Virgil C. Summer Nuclear Station (VCSNS) Units 2 and 3  
Combined License Nos. NPF-93 and NPF-94  
Docket Nos. 52-027 & 52-028

Subject: LAR 13-08 Request for License Amendment: Module Obstructions and  
Details

**Request for License Amendment Regarding  
Module Obstructions and Details**

**Proposed Changes to Licensing Basis Documents  
(LAR 13-08)**

**Tier 2, Figure 3.8.3-8 (Sheet 1 of 3) (Partial)**  
**“Structural Modules – Typical Design Details”**

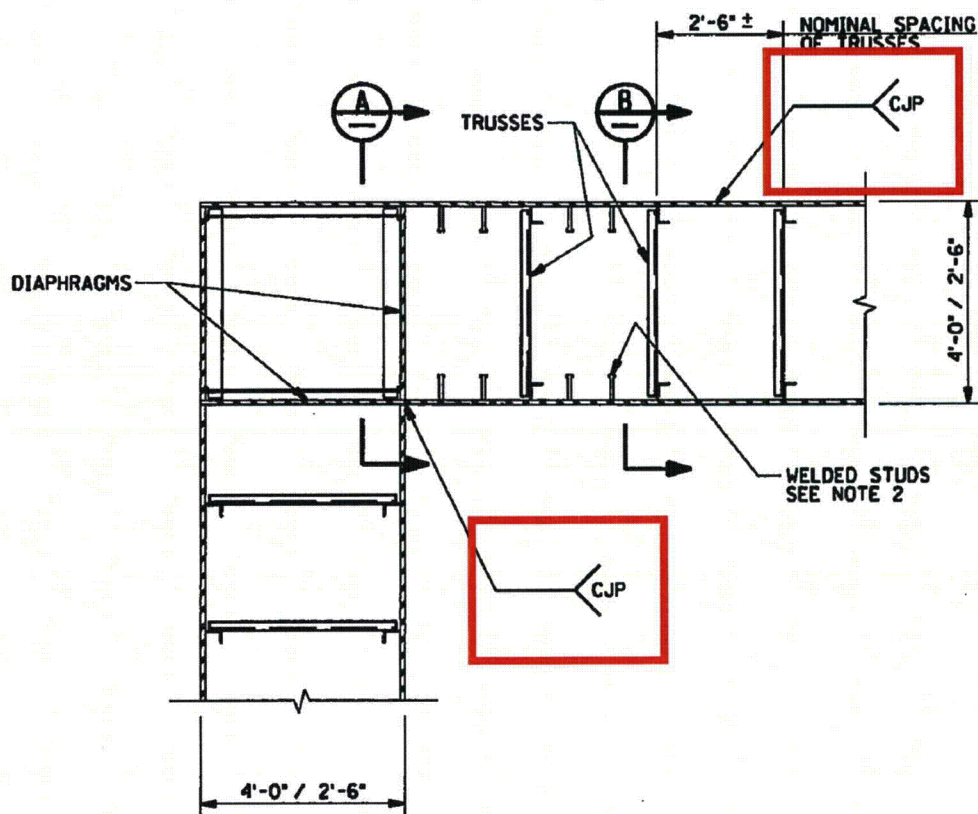
- UFSAR Figure 3.8.3-8 Sheet 1, "Structural Modules – Typical Design Details," the weld symbol for faceplate welds is changed to show a complete joint penetration weld.

The welds between module faceplates in subassemblies and completed modules are required to be complete joint penetration welds. Any weld that provides complete joint penetration including bevel and V-groove welds and that satisfies design requirements and other regulatory commitments is acceptable. Figure 3.8.3-8 Sheet 1 uses the weld symbol for square groove weld for the welding together of faceplates. The square groove weld is one type of complete joint penetration weld. The designation of a square groove weld does not reflect the preferred weld design for module fabrication.

Revise Figure 3.8.3-8 (Sheet 1 of 3) as described and shown below.

In the Detail 1 Plan View, revise the weld symbols to signify Complete Joint Penetration Welds.

Module faceplates are required by the design criteria discussed in the UFSAR to be joined with complete joint penetration welds to provide that the capacity of the plates is developed across the weld seam. A properly welded complete joint penetration provides this capacity. A square groove weld is not the only means to achieve a complete joint penetration weld. Other groove welds such as a bevel or V-groove weld also provide a complete joint penetration weld and with greater facility than a square groove weld.
